Preliminary Plan  
**Symphony Way Extension**  
Sharon Township

| <b>App. No.:</b>  | 034-2022-PP              | <b>Sublots:</b>      | 4                        |

### EXECUTIVE SUMMARY

# PRELIMINARY PLAN FOR SYMPHONY WAY EXTENSION

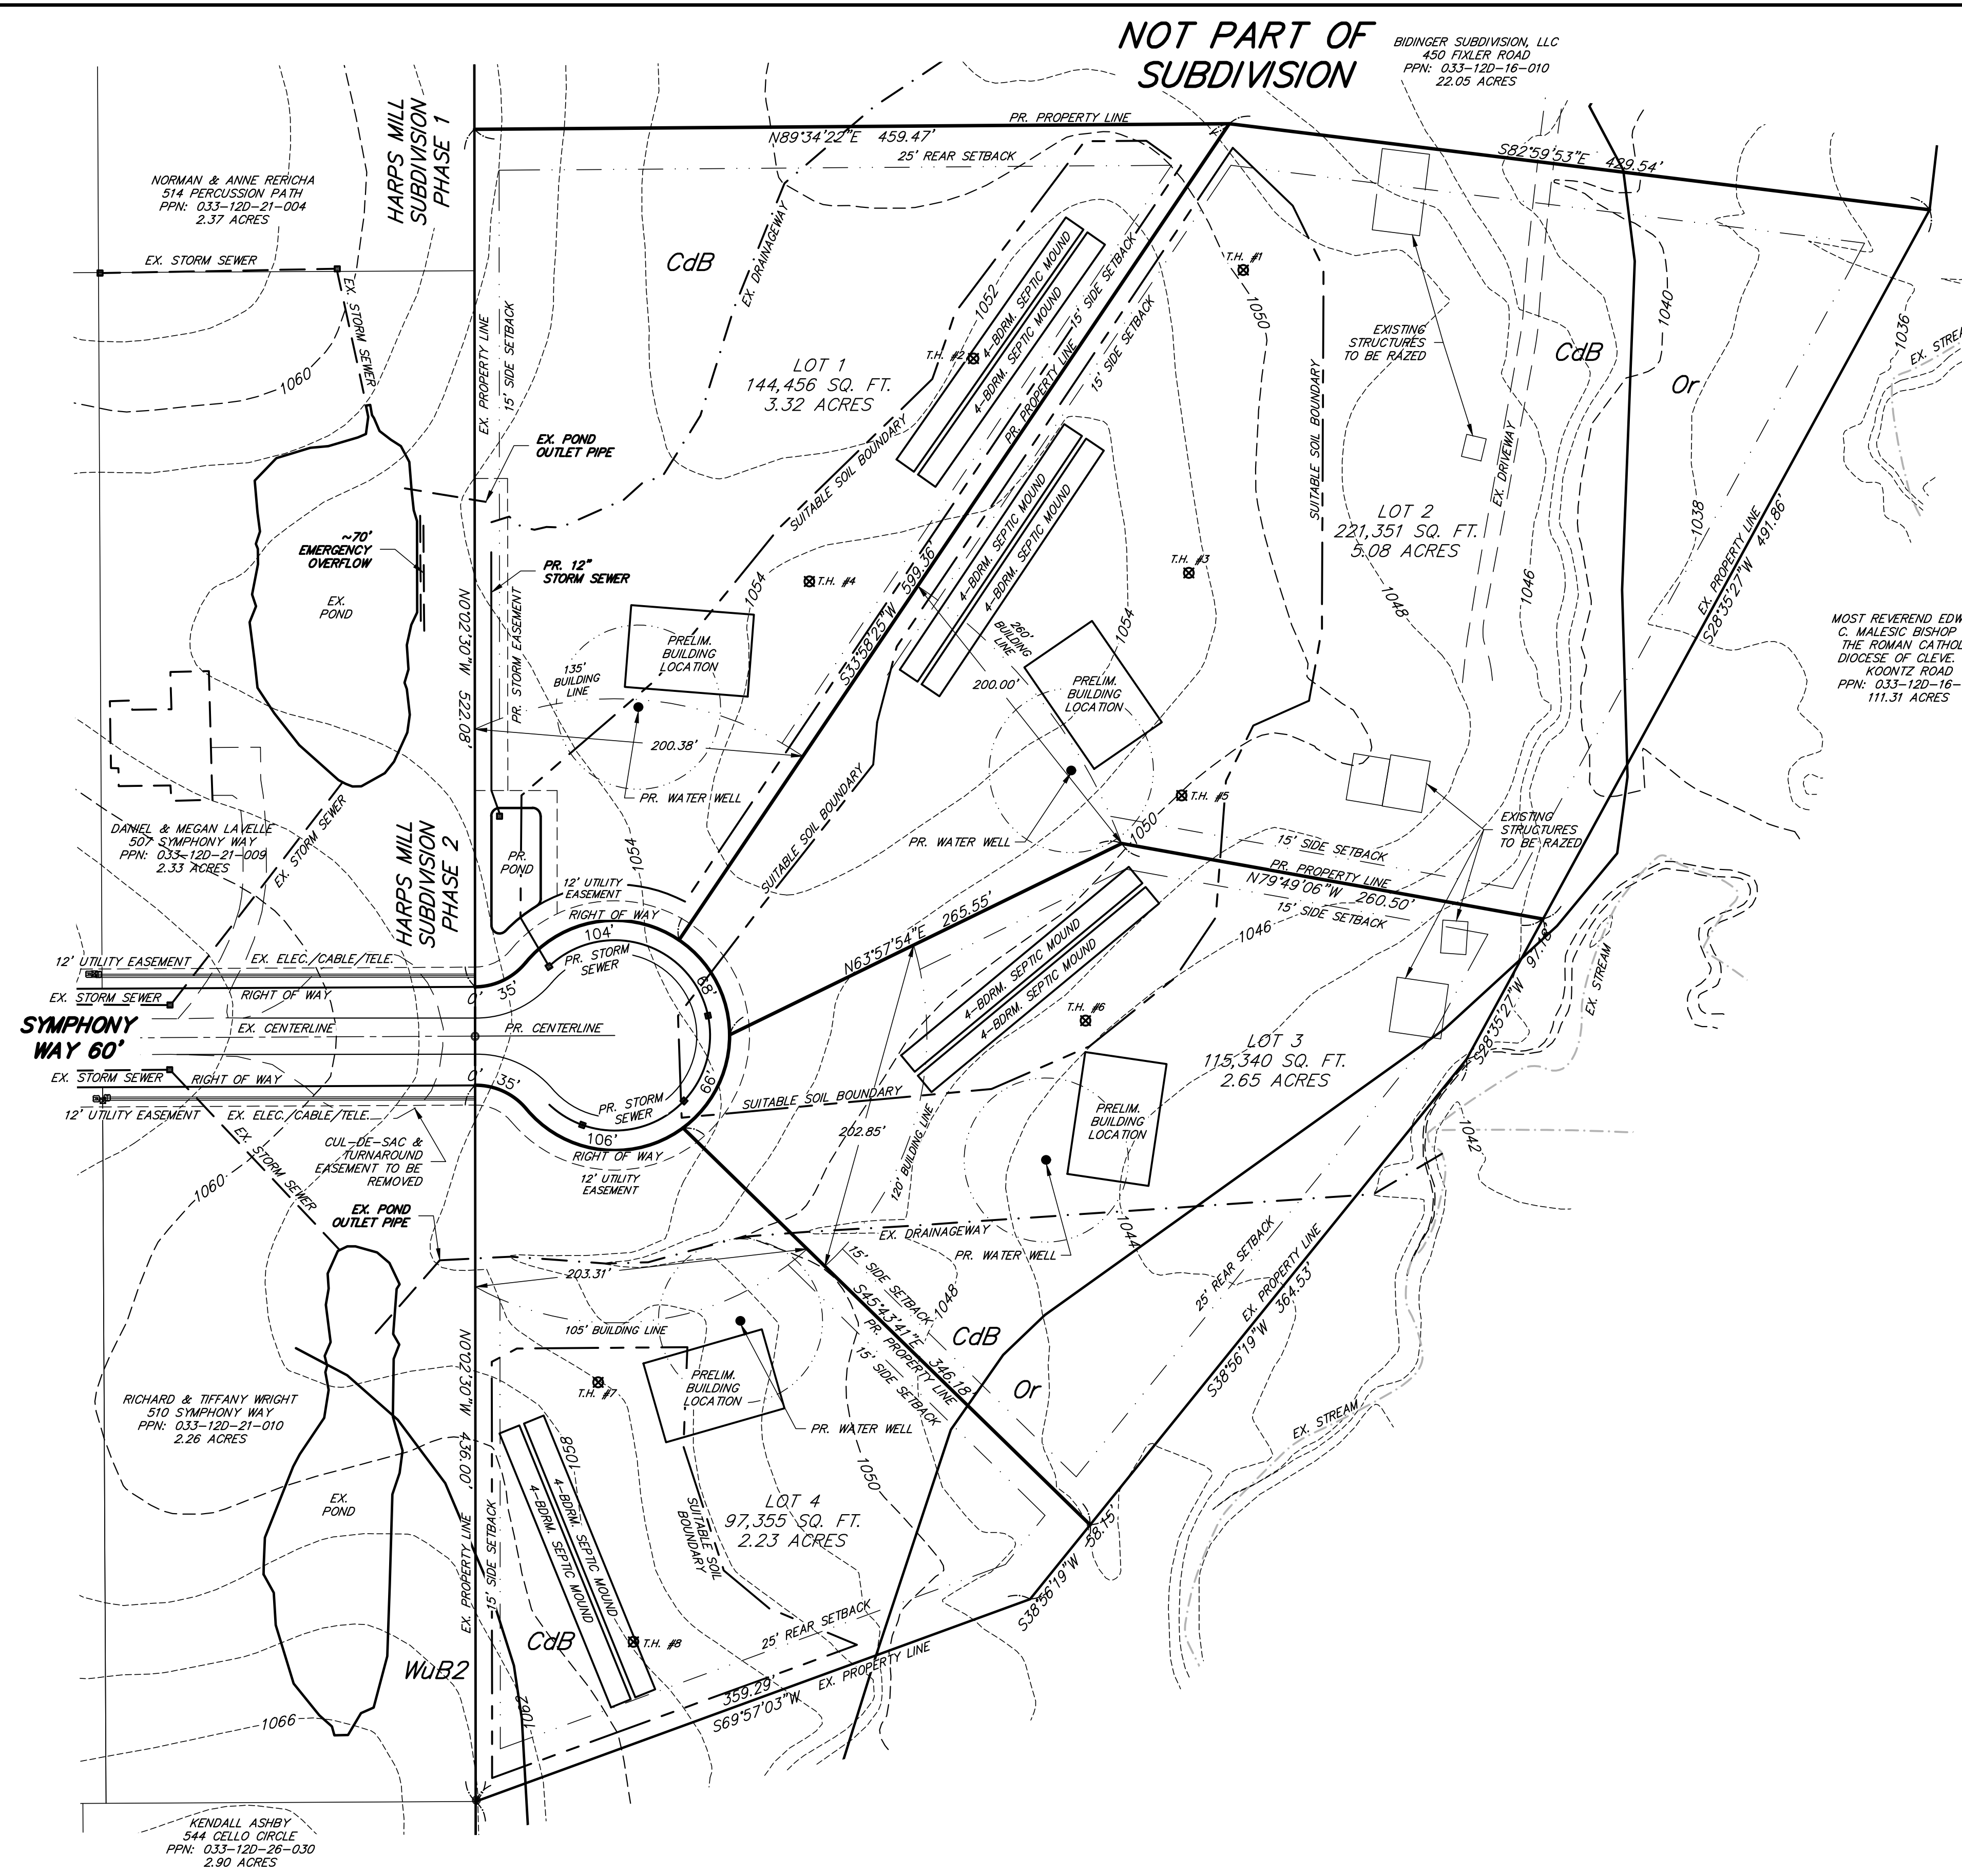
1. *Drainage Maintenance Fund required.*
2. *Maintain existing watersheds.*
3. *Subdivision grading plan to include overland flood routes.*
4. *Subdivision grading plan to accept and accommodate outflows/outlets of existing water quality basins at phase line.*
5. *Show mailbox kiosk location if required by USPS.*
6. *Existing temporary cul-de-sac ears to be removed, typical section to be graded, and existing yards restored.*
7. *Provide an intermediate driveway culvert sizing for Sublot 4 as part of the construction drawings.*

1. *It is recommended that the final plat be submitted to Tax Maps for review before obtaining signatures.*
2. *Check with Tax Maps to determine if subdivision name is available.*
3. *Remove existing parcel numbers and contours from final plat.*
4. *Subject to Medina County Engineer Land Conveyance Standards found at: <http://www.highwayengineer.co.medina.oh.us/surveying/landconveystds.pdf> and to all Tax Map Department comments from previous Planning Department reviews.*

1. All land within a proposed subdivision shall be designated as either a “Block for Development” or “Open Space Block” or “Sublot.” If the northern section of the parcel entitled “Not Part of Subdivision” is not a Block, then this section should be split from the subdivision.
2. Revise the word “Lot” to “Sublot” on the survey.

3. The following data/information was not provided on or with the Preliminary Plan submittal as outlined in Article IV Section (§) C of the Subdivision Regulations:

- a. (2)c.9. The enabling declaration; the declaration of covenants, conditions and restrictions, the articles of incorporation; and the corporate by-laws.

- b. (2)c.18. Wetlands –The developer shall contact in writing the applicable U.S. Army Corp of Engineers District Office regarding the proposed subdivision, and shall submit such correspondence to the Medina County Planning Commission as a condition of Preliminary Plan approval. The applicant has submitted Appendix 1: Request for Corps Jurisdictional Determination.

- c. (2)d.4. All related watershed boundaries, indicating in which watershed the subdivision is located, and all known underground drainage tile systems. This may be presented as a map insert on the same page.

- d. (2)d.7. A copy of the Developers Notice of Intent to obtain an Ohio E.P.A. stormwater management permit if applicable.
4. The Preliminary Plan meets the standards and requirements of the Subdivision Regulations and appears to conform to the Township Zoning Resolution per §404(C)(4)b.1. The Township indicated the Preliminary Plan is approved.

5. The Medina County Health Department needs to determine the proposed lots are suitable for on-site wastewater systems. §404(C)(4)b.2.
6. The Medina County Highway Engineer has determined the Preliminary Plan for streets, stormwater management and natural drainage ways protection are acceptable subsequent to the approval of more detailed construction drawings per §404(C)(4)b.3.

**Department of Planning Services Recommendation:** Staff recommends that the Medina County Planning Commission **APPROVE WITH MODIFICATIONS** the Preliminary Plan for the Symphony Way Subdivision subject to the following:

1. Satisfy required agency and DPS comments listed in the staff report above.
2. Submit the required data/information as listed above.
